# ADDENDUM NO. 3

### November 28, 2022

# JACKSON ELEMENTARY SCHOOL RENOVATIONS Valparaiso, IN 46304

This Addendum consists of page ADD 3-1 and attached Addendum No. 3 from Gibraltar Design dated November 23, 2022 and consisting of 7 pages and 42 drawings.

P-112

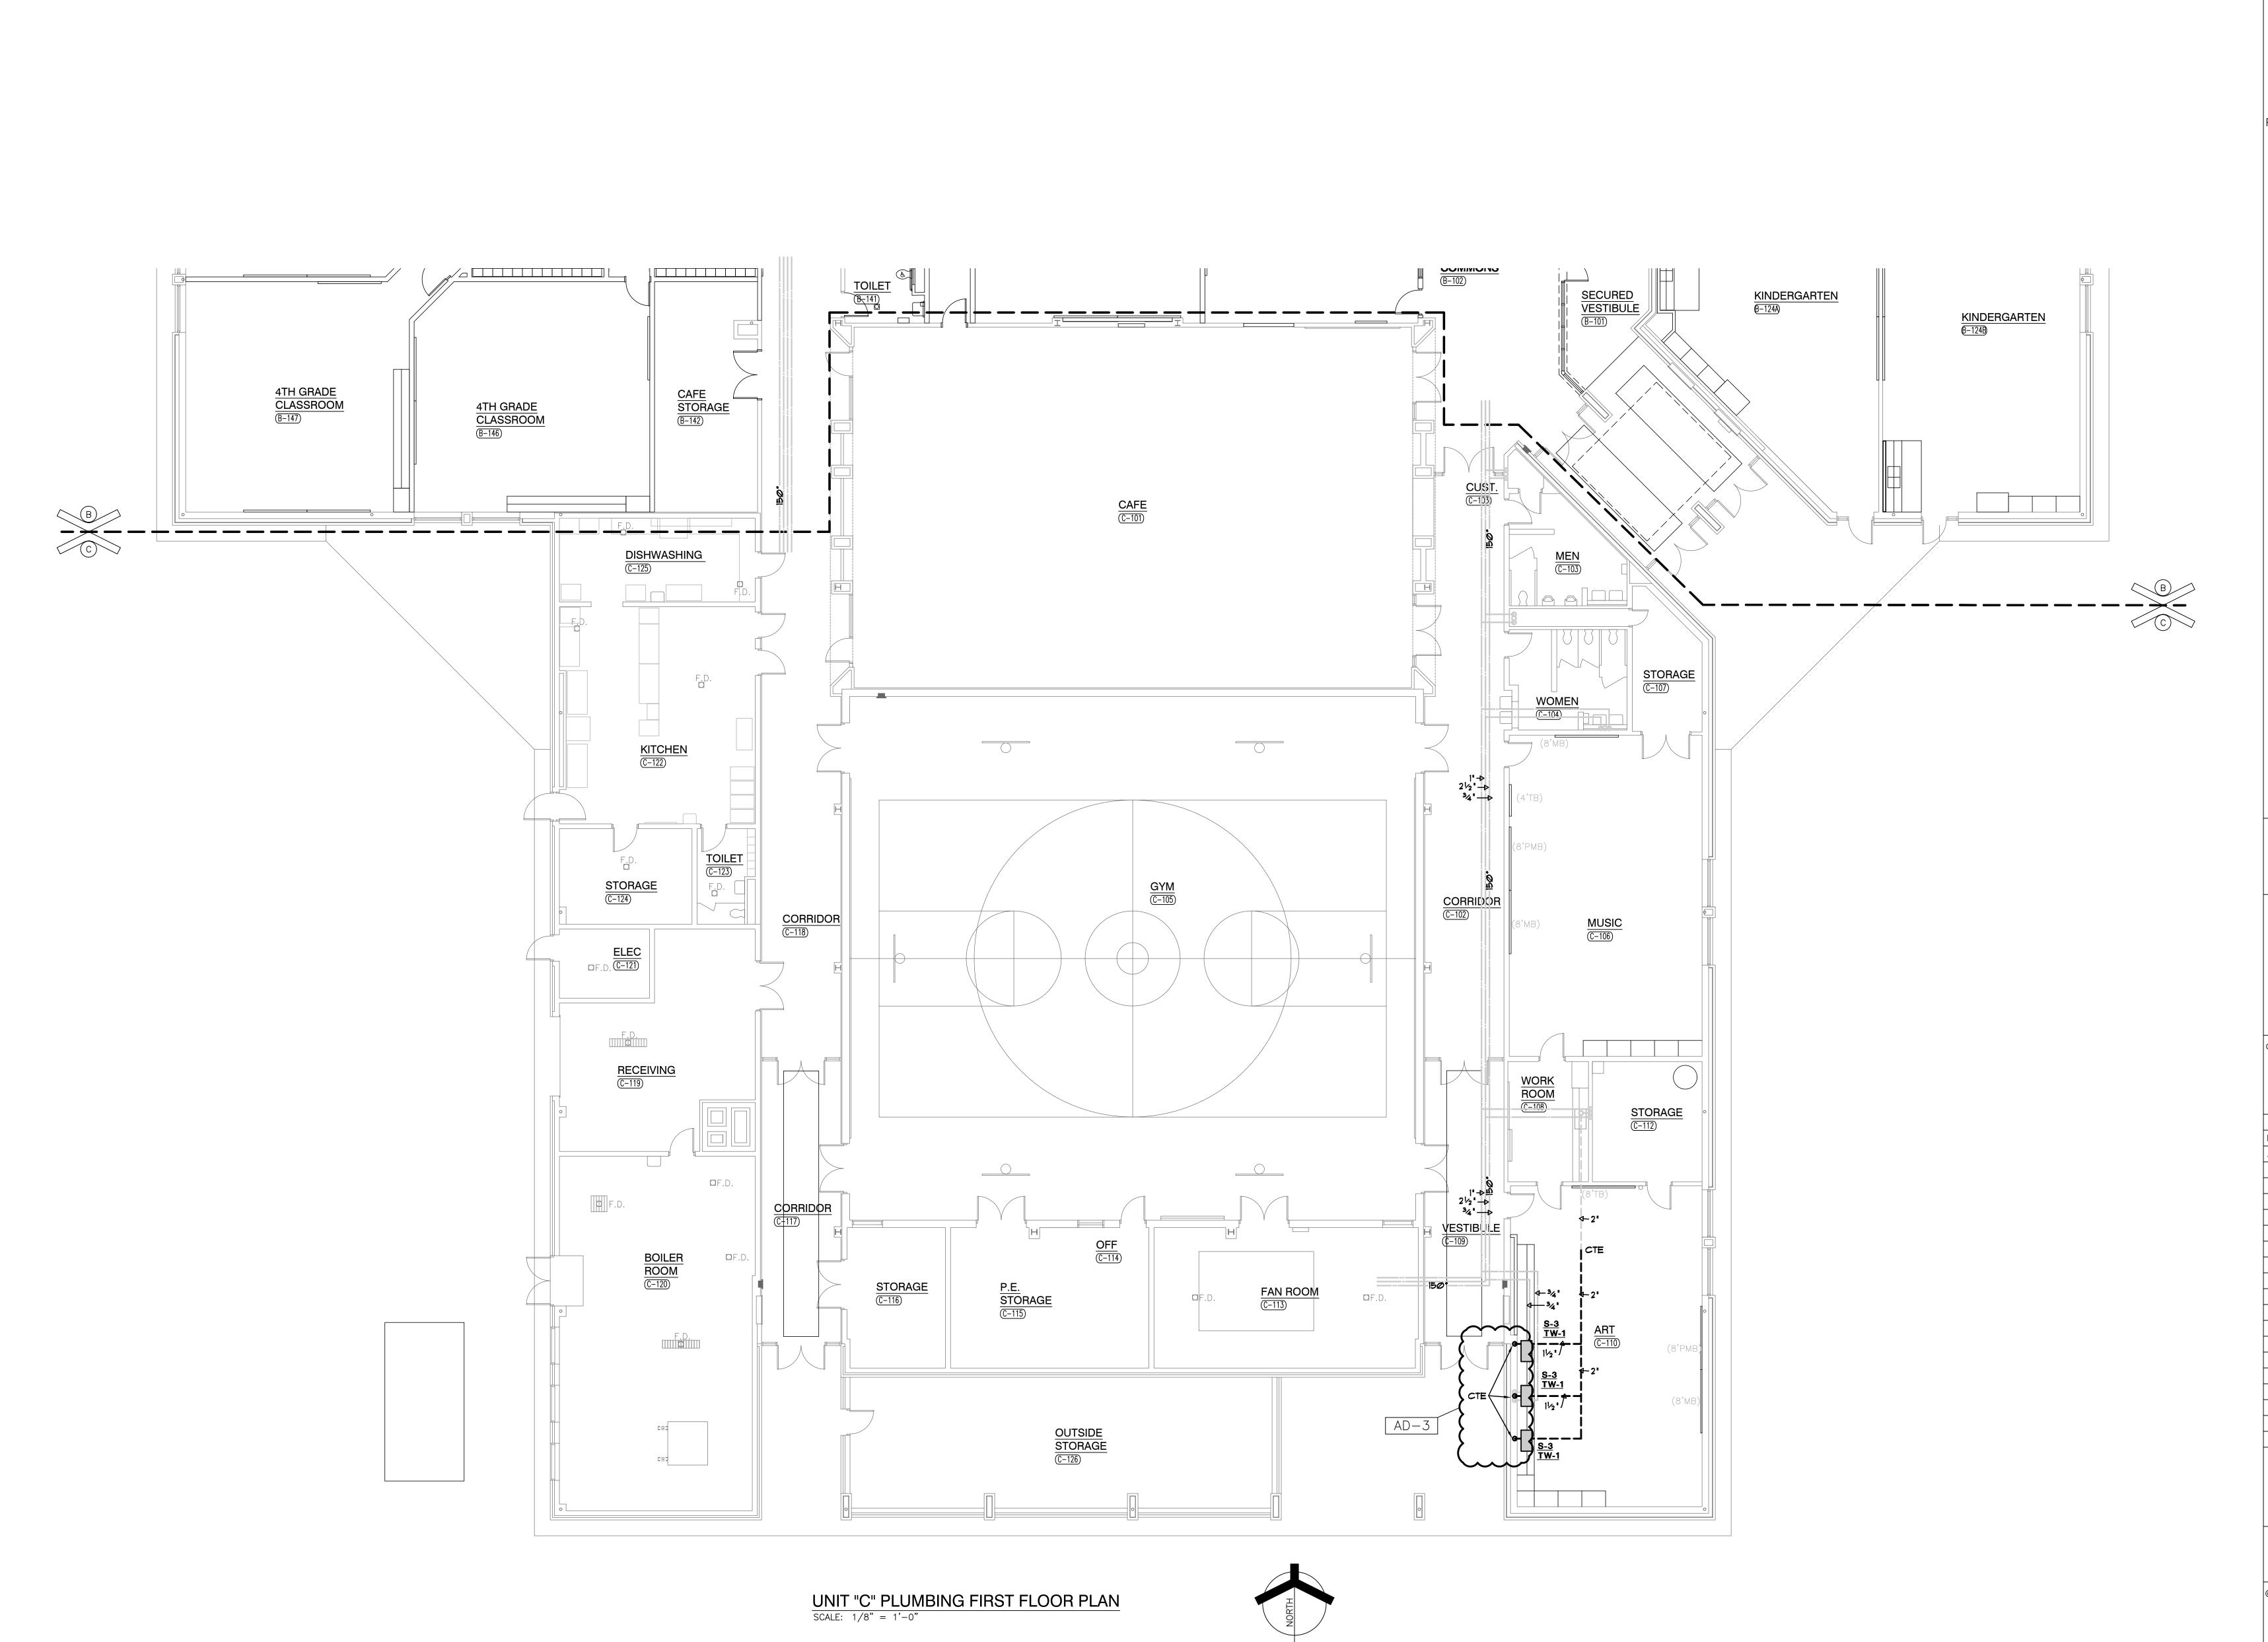
- A. Refer to revised full size drawing, included in this Addendum, for the following revisions:
  - 1. Clarified pipe size down to B-157 and B-158 chase.
  - 2. Clarified connecting new CW, HW and vent to existing piping.
  - 3. Added IM-1 in Clinic B-111.
  - 4. Clarified connecting new CW and HW to existing piping.

MD104

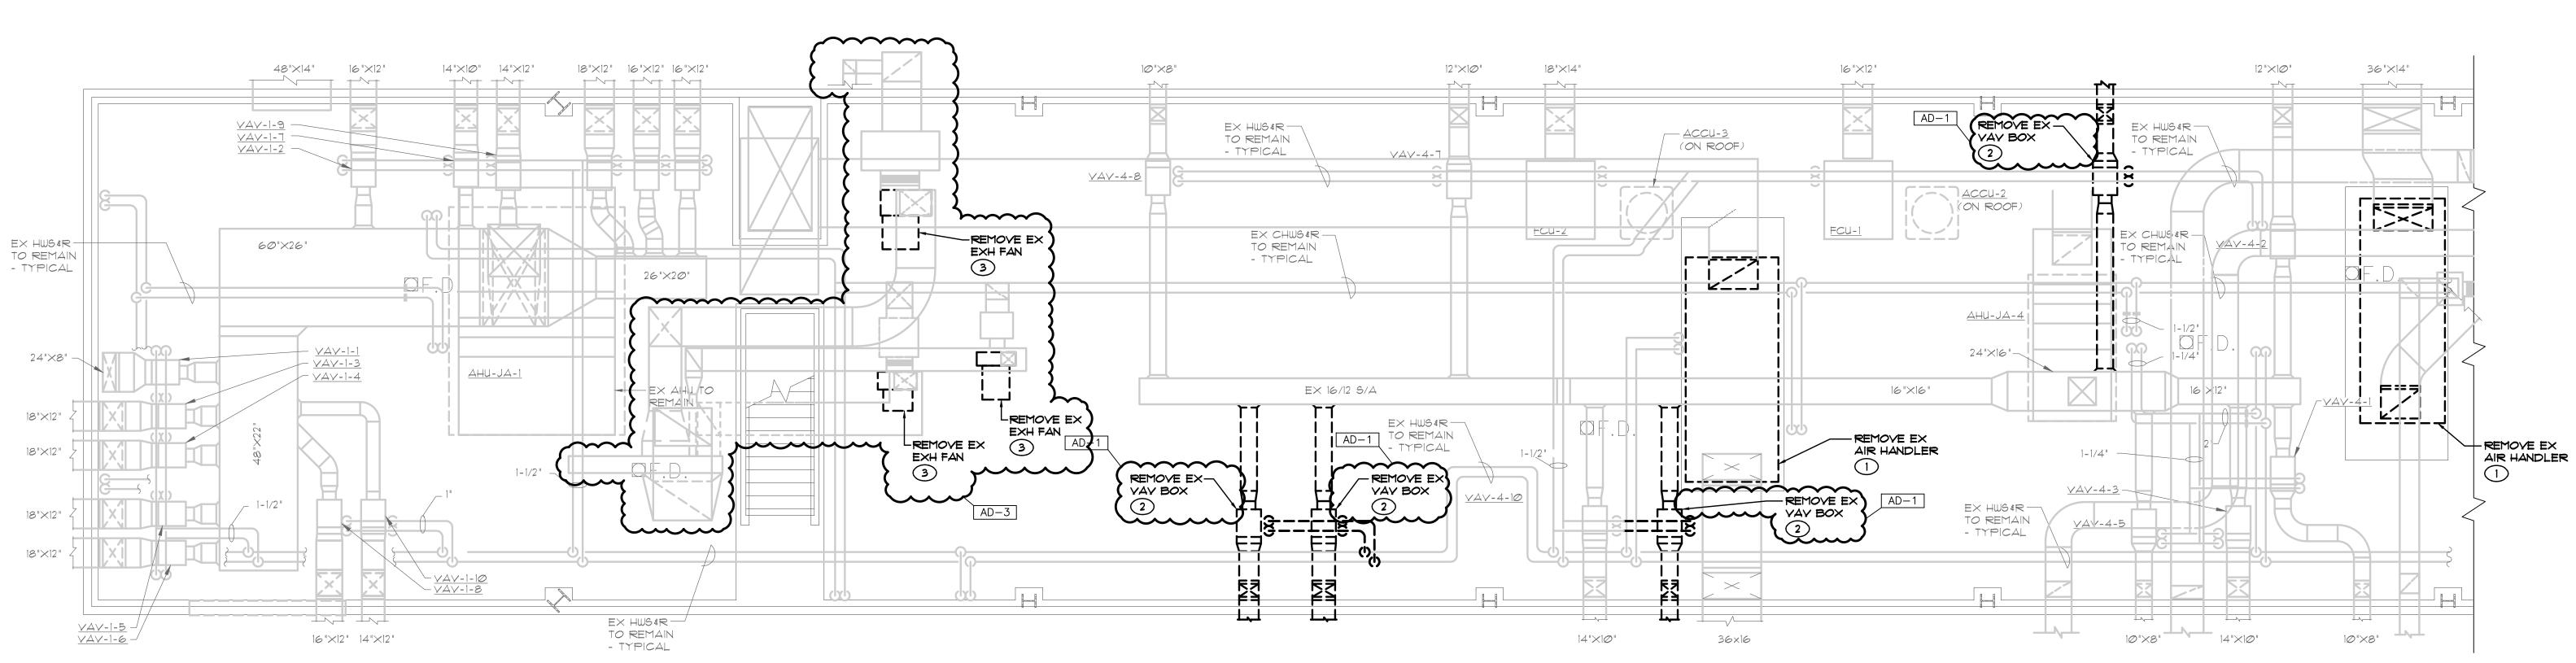
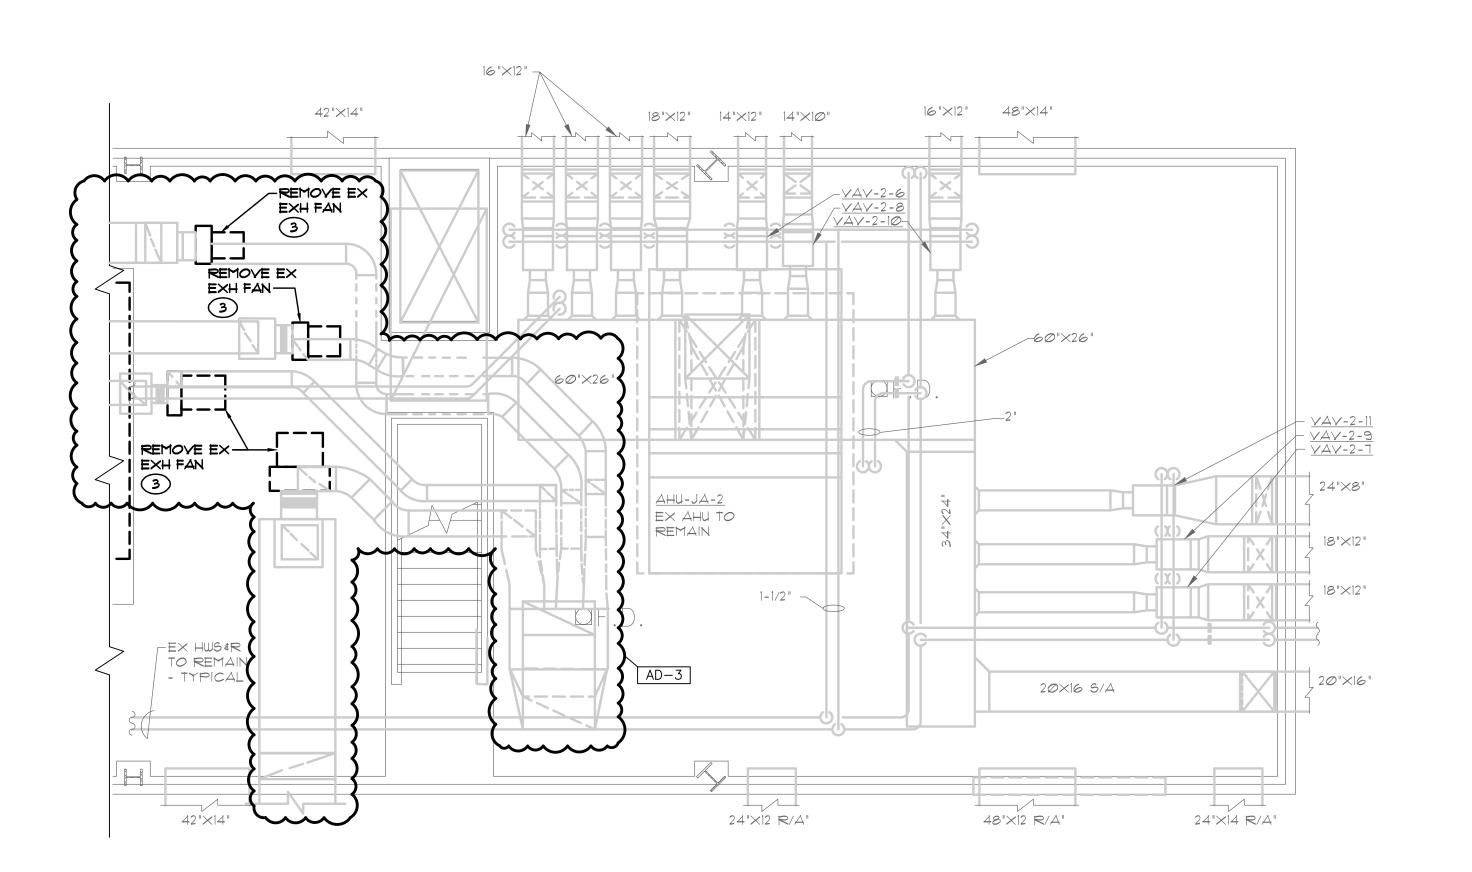
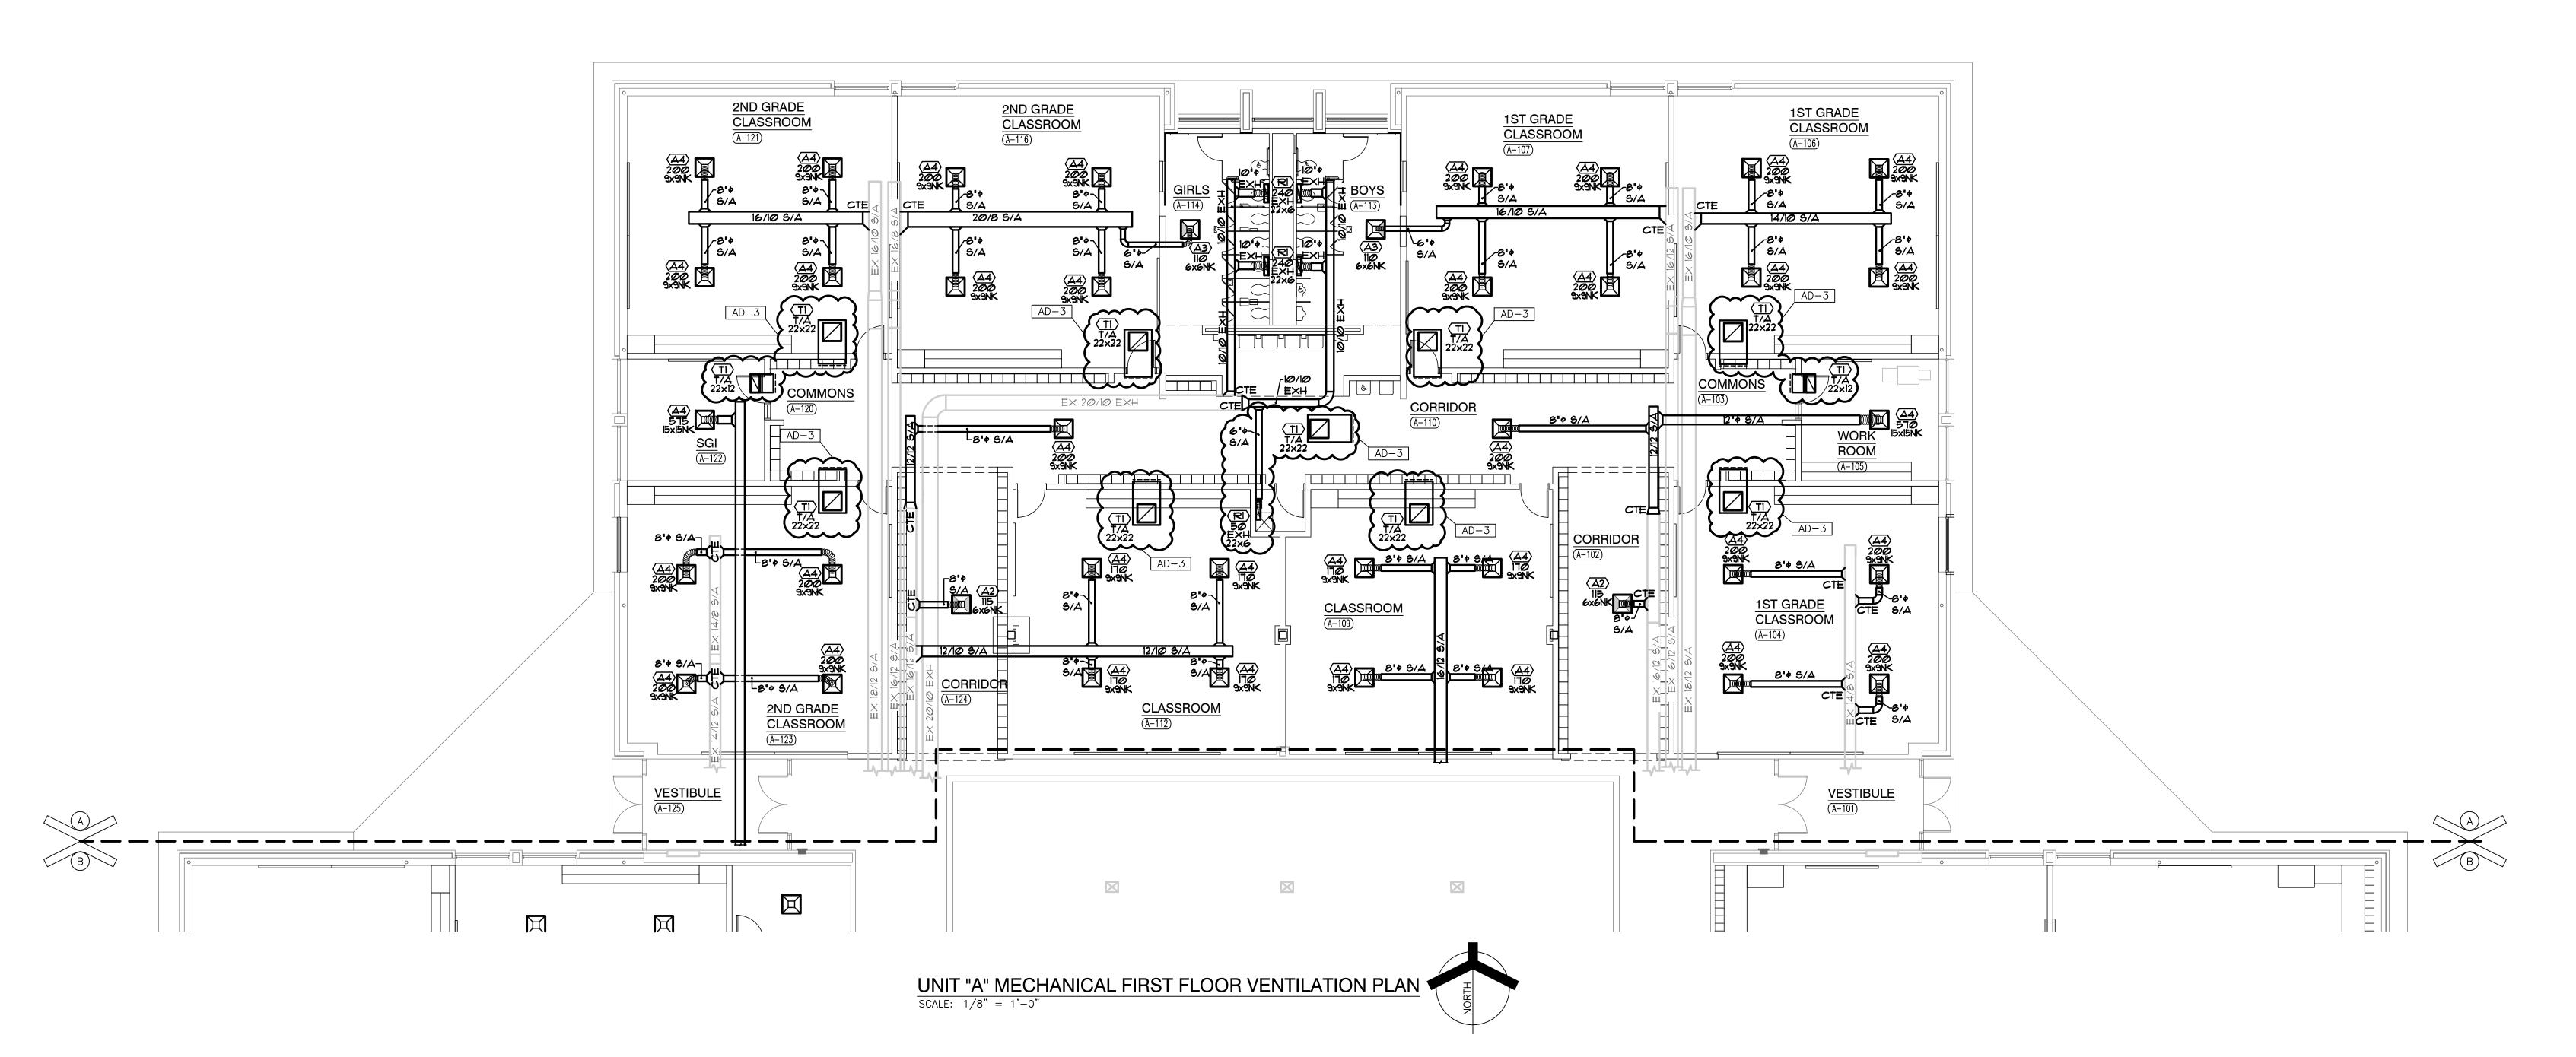
A. Refer to revised full size drawing, included in this Addendum, for added demo exhaust fans.
